**SUBJECT: COMANCHE PEAK NUCLEAR POWER PLANT, UNITS 3 AND 4
DOCKET NUMBERS 52-034 AND 52-035
SUPPLEMENTAL INFORMATION FOR THE ENVIRONMENTAL REVIEW RAI**

SUPPLEMENTAL RESPONSE TO REQUEST FOR ADDITIONAL INFORMATION

RAI REGARDING THE ENVIRONMENTAL REVIEW

Comanche Peak Nuclear Power Plant
Squaw Creek Reservoir
Wetland Delineation
Figure 3

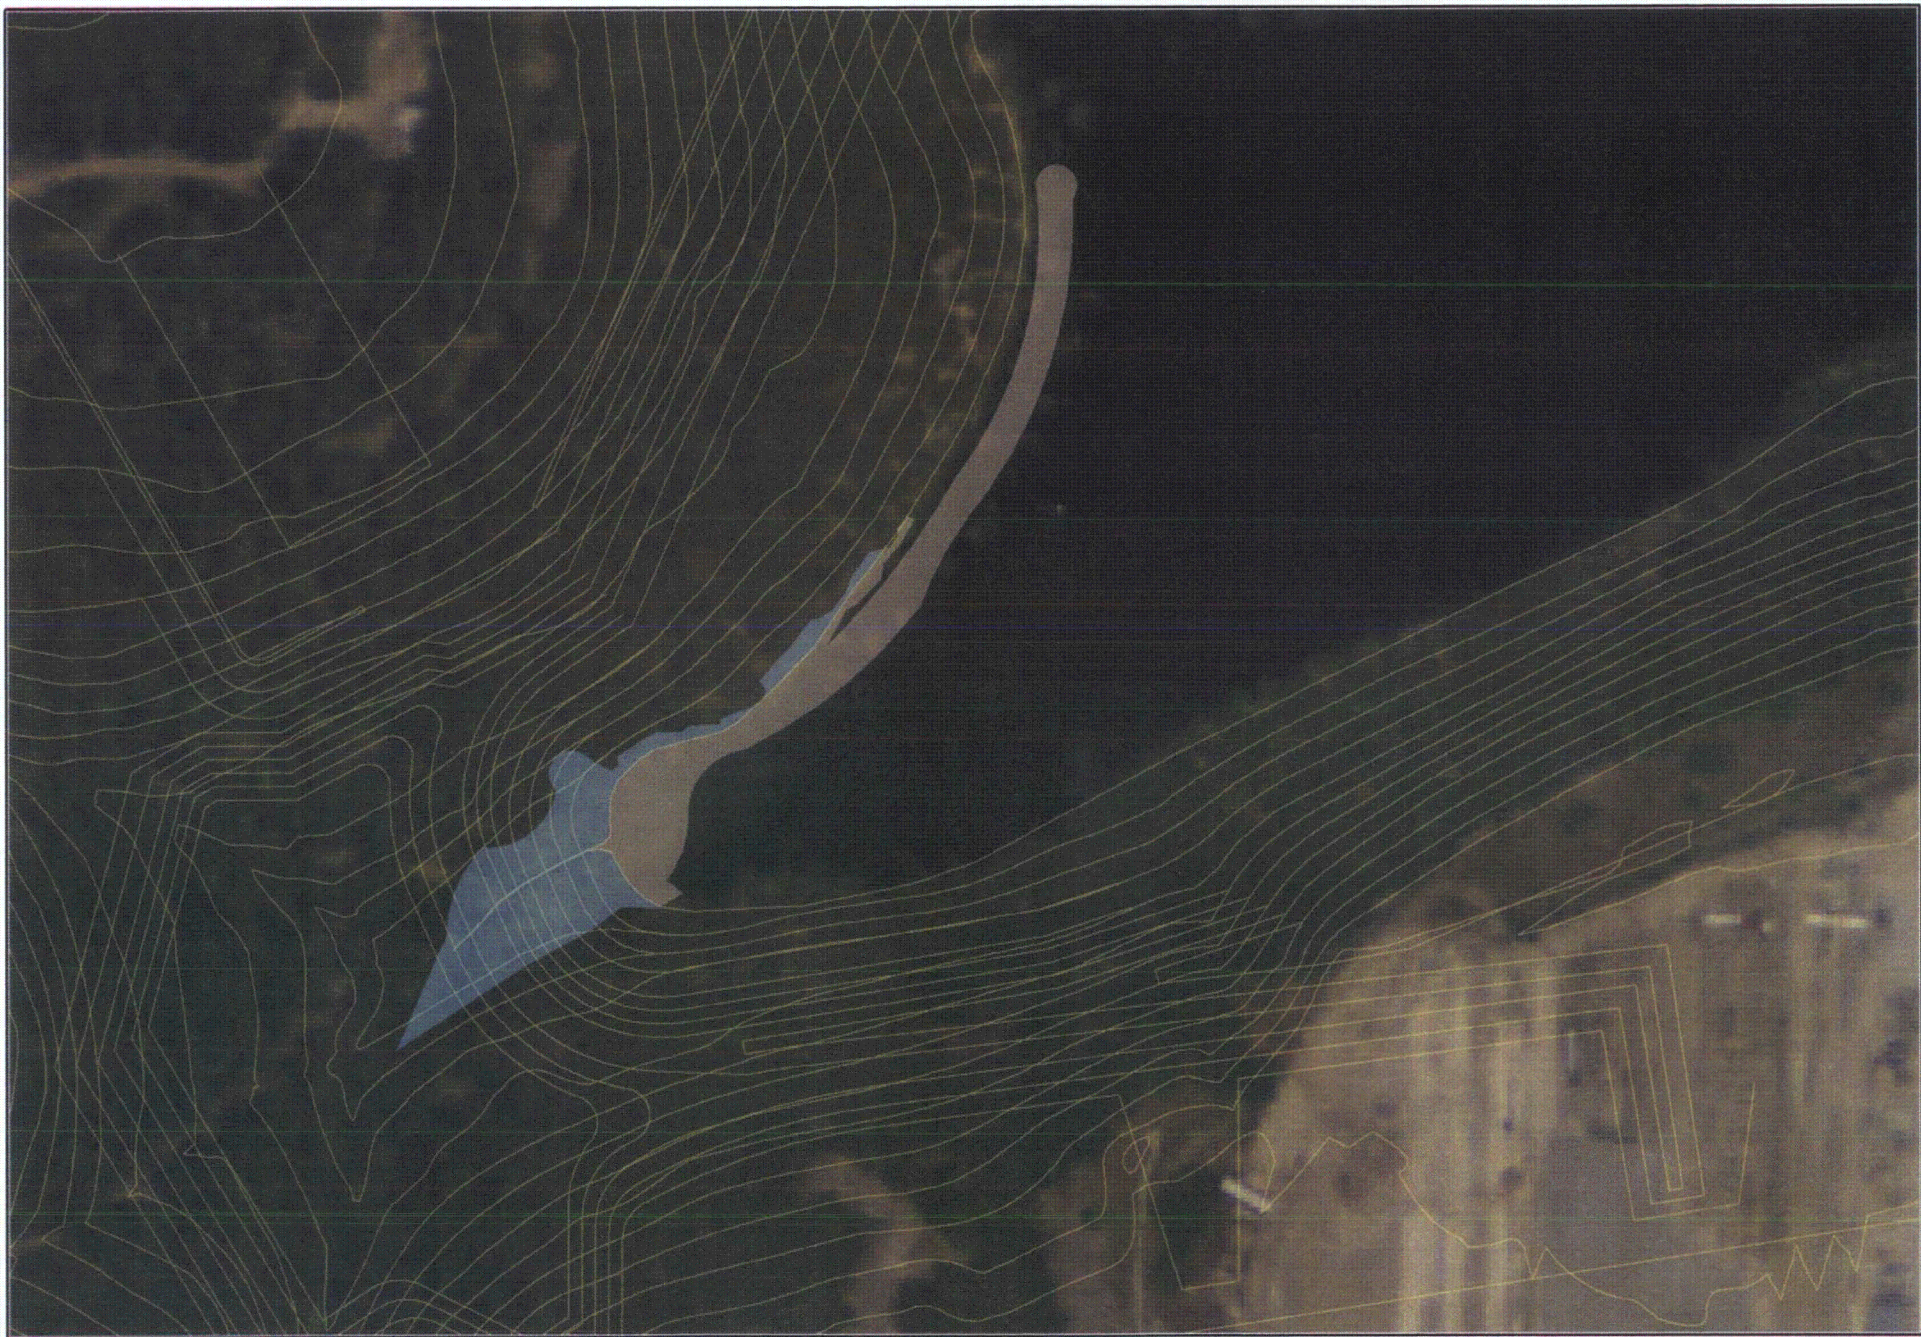
Please provide a functional assessment for any mitigation proposed for aquatic resources, including wetlands, which demonstrates replacement of lost wetland functions.

A small wetland area along the inlet southwest of the cooling tower peninsula is currently within the construction area. While very small, disturbance to this area was discussed with the NRC.

Environmental Report Figure 4.3-1 shows the wetland of interest and the potential for partial disturbance. As noted in ER Subsection 4.3.1.4, the U. S. Army Corps of Engineers (USACE) is responsible for determining jurisdiction over wetlands and providing guidance regarding compensatory mitigation and the need for permitting. During the NRC Environmental Review Site Visit (Ecology portion) in February 2009, the drainage map for the proposed site was reviewed and a planned storm water sedimentation pond was superimposed over the areas of concern. The pond is shown on FSAR Figure 2.4.2-202. The sedimentation pond will partially affect the wetland of interest. Total acreage of the wetland is 0.78 acre. The affected portion is estimated at 0.35 acre or 45 percent of the total, leaving 0.43 acre or 55 percent of the wetland intact. The attached revised Figure 3 from the "Wetland and Other Potentially Jurisdictional Waterbody Identification and Delineation Report" indicates the area that will be affected.

Luminant's conclusion is that the environmental impact of disturbing this wetland area to construct a sedimentation pond has little or, in the long run, no environmental impact. The disturbance may well be overshadowed by the value of the sedimentation pond, which will protect the quality of SCR, especially in this section of the reservoir, and the potential new wetlands that may develop over time in the same area.
